**LEXINGTON-FAYETTE URBAN COUNTY
GOVERNMENT CONTRACT CHANGE ORDER**

Date:	February 2, 2015
Project:	Senior Citizen Center Constructio
Location:	Lexington
Contract No.	227-2014
Original Contract Amt.	\$8,882,900.00
Cumulative Amount of Previous Change Orders	\$129,440.47
Percent Change - Previous Change Orders	1.46%
Total Contract Amount Prior to this Change Order	\$9,012,340.47
Change Order No.	7

JUSTIFICATION FOR CHANGE

PROJECT: Senior Citizen Center Construction

CLIENT: LFUCG
PROJECT: Senior Center
SUBJECT: Undercut

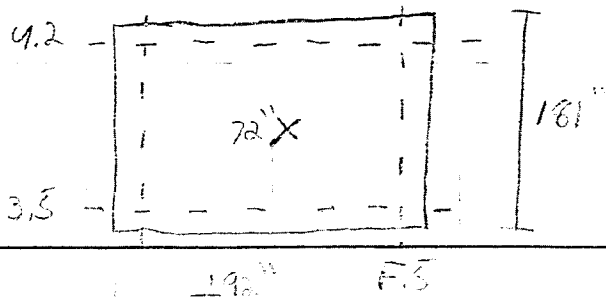
Cal. Footings @ C.L. F.5/3.5 + 4.2
+ E.9/3.5 + 4.2
flow carry-over
@ 915 PM. Elevate Pier Footings

- Bearing observation revealed top soil.
- Undercut to 24" below.
soil tan to grey, saturated silty clay. -1000 psf.
- Undercut to 5' below bearing
tan to grey, saturated silty clay
w/ large void located @
Top of Rock.
- Undercut to expose apparent
bedrock.

Total depth \approx 6' below bearing.
total volume \approx 192" x 181" x 72"
E.9 53.63 yd³

Flowable fill placed.
